Reference: 14.289r03v03

**Re: The Terraces - Seniors Living and Residential Aged Care Facility
74 Brown Street, Paddington
Removal of Significant Trees 5 and 130**

**RE: Arboricultural Assessment of Supporting Removal of Tree 130 Sydney Red Gum:
MP10_0016 - "The Terraces" 2 Cooper Street, Paddington**

Excerpt from *Site Plan, DA101 Rev. P11* by JPRA.

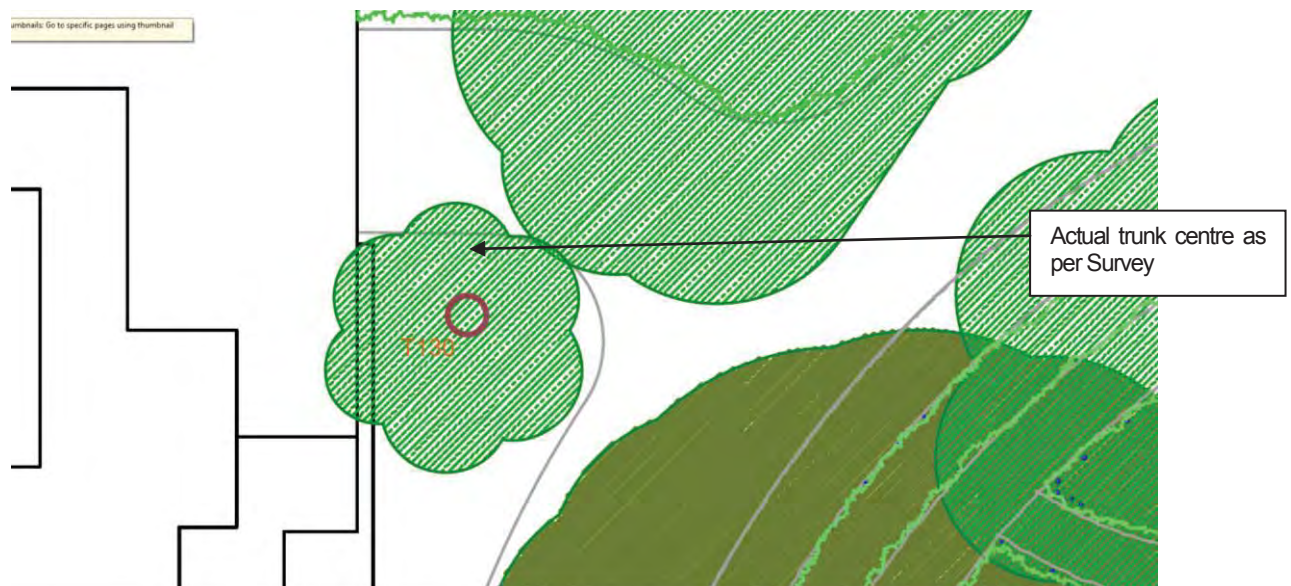
The assessment of the impact of the proposed building works on the tree in the Arboricultural Impact Assessment report for the DA (Ref: 246DAIA, September 2010) was in error. The close proximity of the trunk of the tree to the proposed Driveway ramp to the basement was not accurately assessed. The earlier tree number (#16) on the Survey was misinterpreted by some as the trunk of the tree. The actual trunk centre is at ERL 16.14 as indicated.

The JPRA Architectural set, Rev. P11, 7.09.10 reviewed for the AIA, September, 2010 had the trunk shown as the tree number rather than the trunk centre, marginally further from the proposed ramp than shown on the current Drawings.

Excerpt from *Level 01 Plan A-P-1103, Rev 10* by JPRA. Refer to Attachment C of detail of Sections 1 and 2.

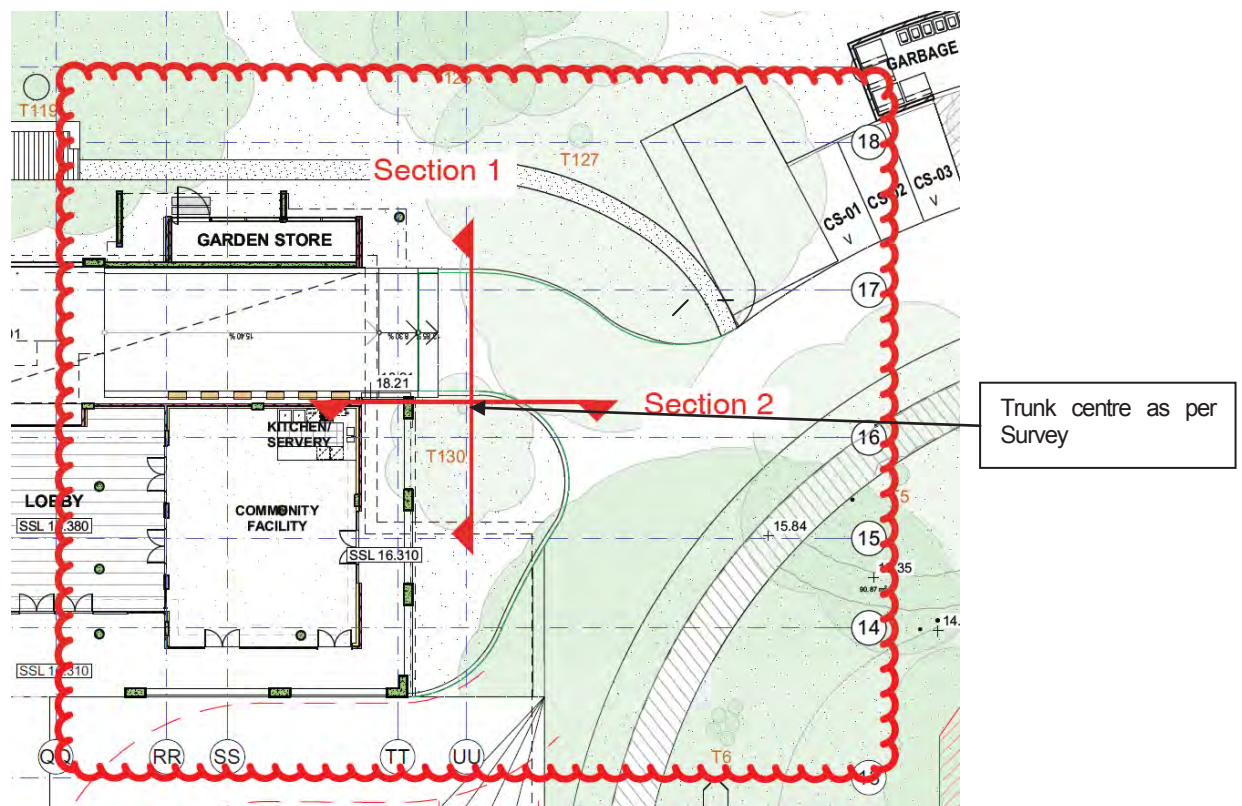
The current construction drawings show the actual trunk location well within the Structural Root Zone (SRZ) (2.8m) of the tree. In fact the excavation needed for the Driveway ramp down to the Basement is within 1m of the base of the tree and will result in root cutting on the tension side of the tree.

Attachment C: Markup 3.12.16 of External Works Sections A-P-1116, Rev 2

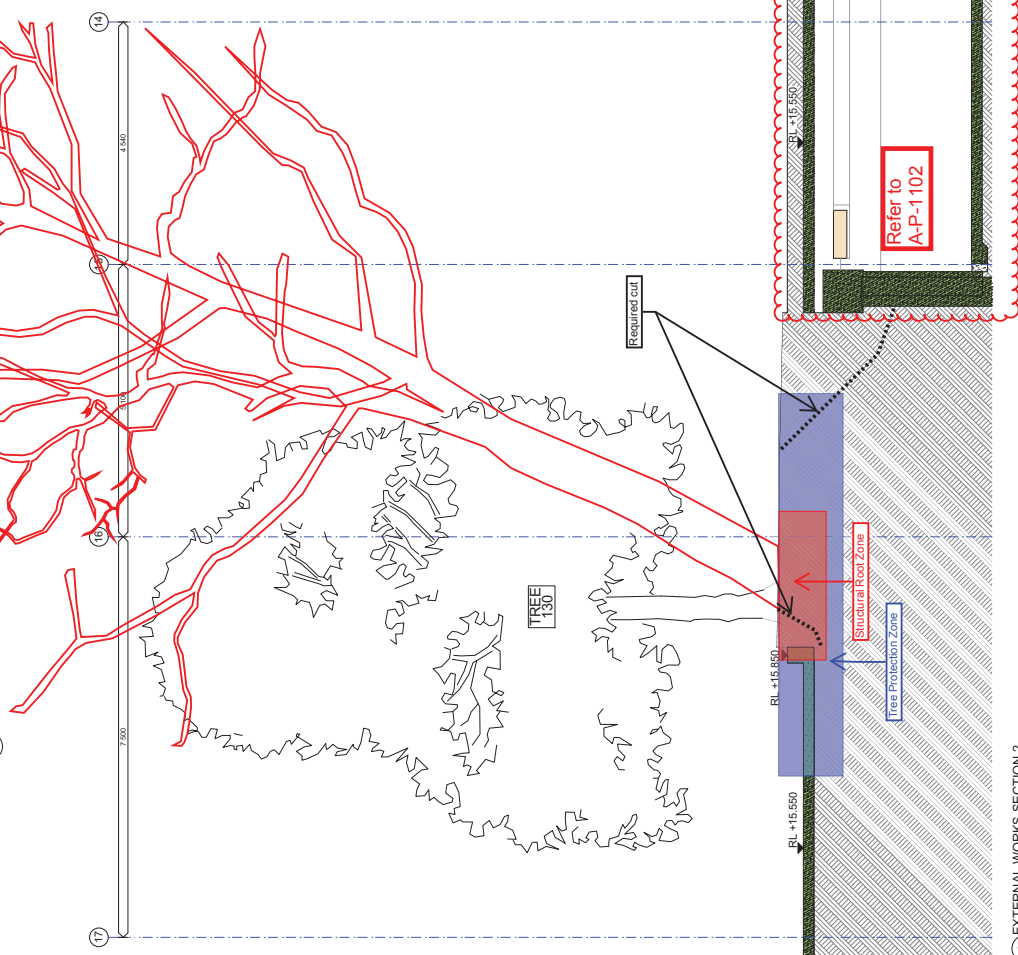
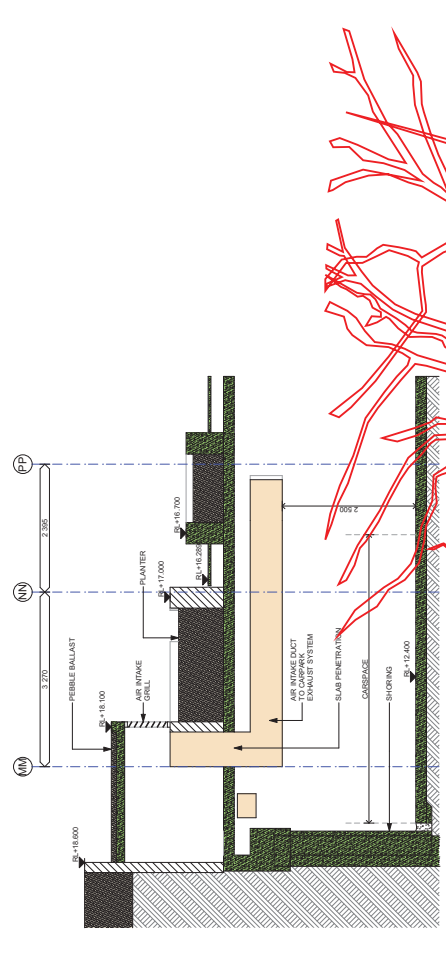
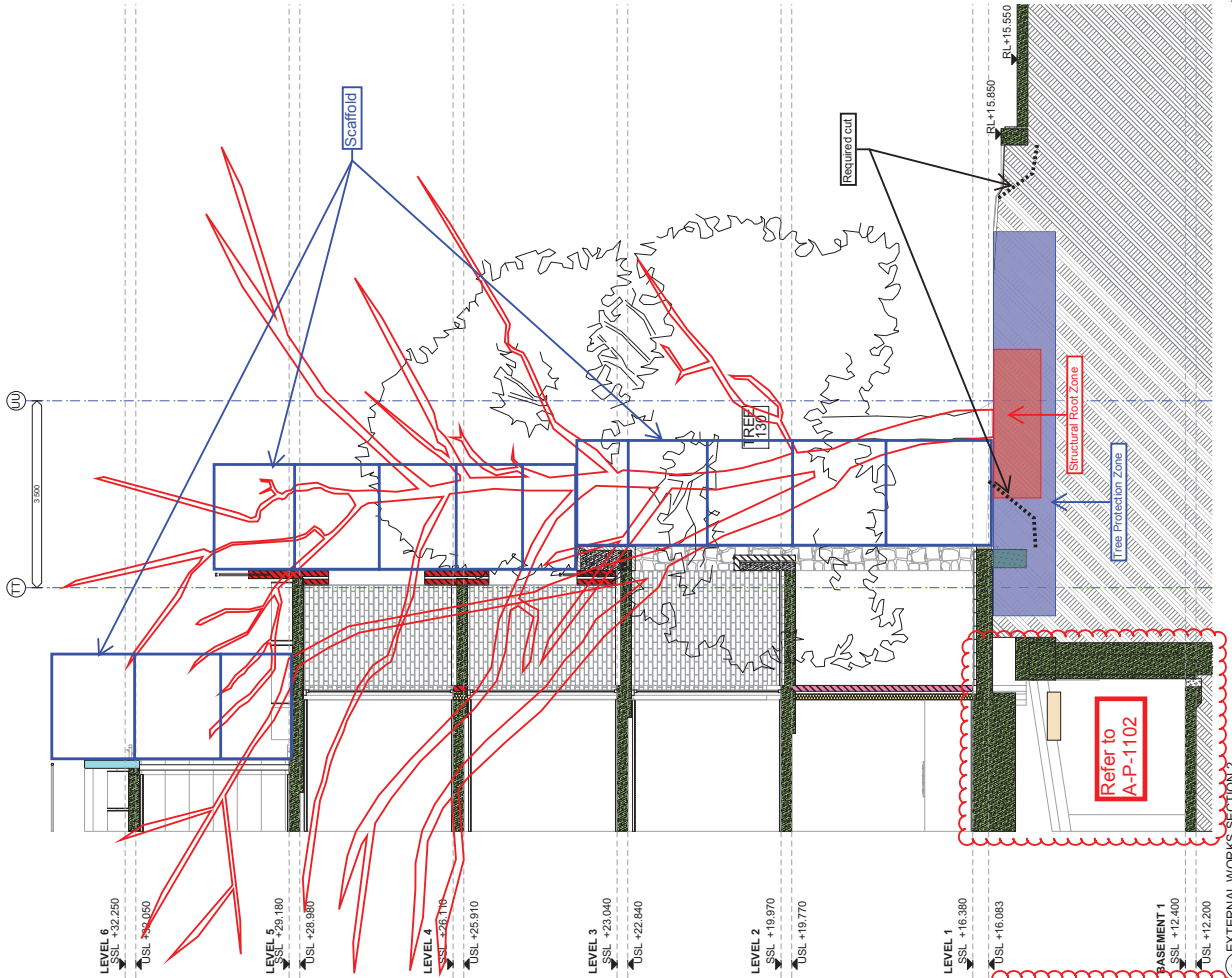
The External Works Sections Drawing A-P-1116, Rev 2 by JPRA has been marked up by Brookfield Multiplex Site Manager 3.12.06 (Attachment C) to accurately show the proposed excavation and the actual lean of the tree.

Section 1 shows the existing ground lines and proposed cut required for the Driveway ramp. Substantial cut for the proposed Driveway ramp is required at the base of the trunk to the west well inside the SRZ. Section 2 shows the cut required for the Basement (Grid line 15) within the Tree Protection Zone (TPZ) (7.2m) and excavation for the Basement (Grid line TT) within the SRZ. The tree will be destabilised by these combined excavation works within the SRZ, particularly given the lean of the tree away from Driveway ramp line of cut.

The crown of the tree is skewed to the south as indicated in Photo C, in the Survey excerpt above and as indicated in the External Works Sections markup (Attachment C). Substantial crown pruning would be required to allow for the proposed building facade and the scaffold required for the construction. As indicated in Section 2 (looking west) scaffolding is required in line with the base of the trunk. Even if the building were to be constructed without external scaffolding, the southern-most leader would need to be pruned to the main junction at approximately 3m above ground level and all the southern branches would need to be pruned to provide reasonable building clearance. This extent of crown pruning would render the tree significantly disfigured such that its ULE would be reduced and the landscape amenity provided by the tree would be lost.

OPTION A - TREE 5 REMOVED

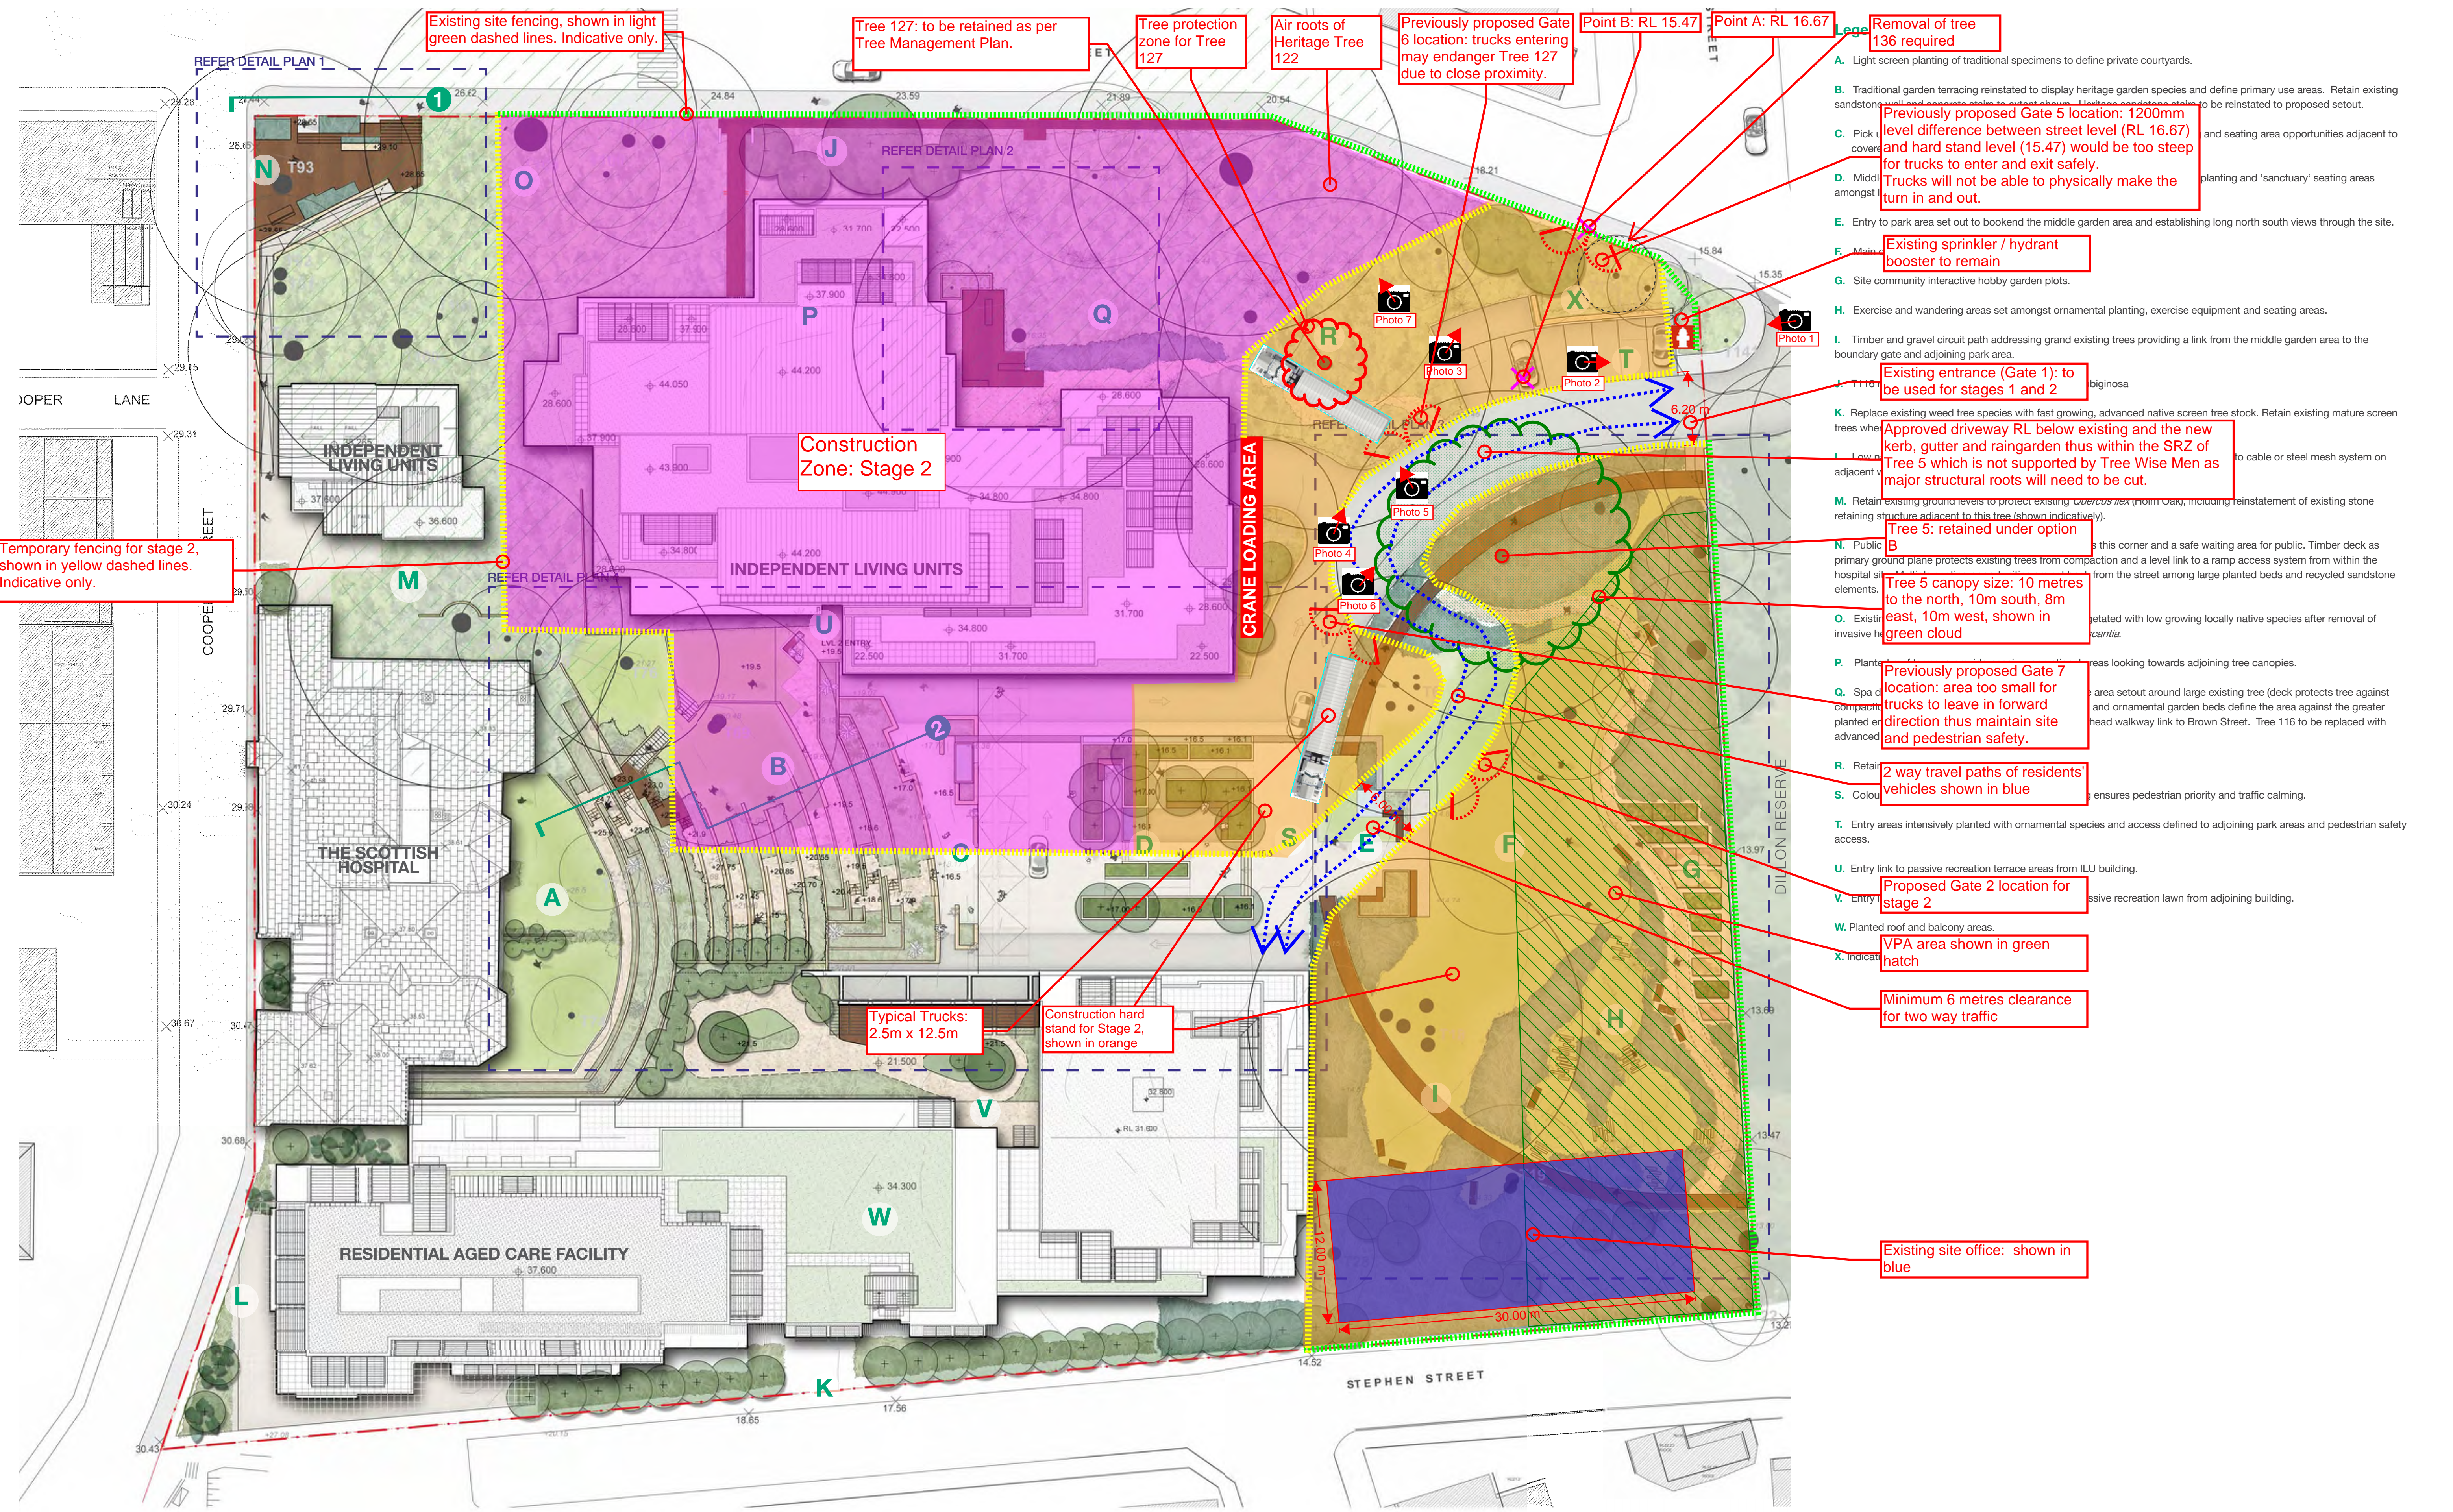
Whilst Option B would ensure that Tree 5 is able to be retained, this arrangement is considered unsatisfactory for the following reasons:

- The internal arrangements would not permit trucks to satisfactorily turn around within the site, ensuring that they could exit the site in a forward direction. Forward entry and exit manoeuvres to the site are essential for both safety and efficiency reasons, as well as being a requirement under Condition B7 of the development approval (MP10_0016). Specifically, reverse manoeuvres would most likely be required from previously proposed Gates 5, 6 and 7.

- The change in levels between the street and hardstand at the previously proposed Gate 5 is approximately 1.2m. This is considered a significant grade that trucks would need to reverse up in order to exit the site, which is considered unsafe. This would also result in efficiency concerns along Brown Street as through traffic would need to be held by traffic controllers each time a truck exits the site.

- The construction access driveway at the previously proposed Gate 5 would be situated in a prohibited location having regard for Figure 3.1 of AS 2890.1 (2004), rendering it unsafe.

Taking the above into consideration, it is our view that Tree 5 should also be removed to ensure construction vehicles are able to safely and efficiently enter and exit the site in a forward direction, as would be allowable through the implementation of the Option A site access and internal traffic circulation arrangements.
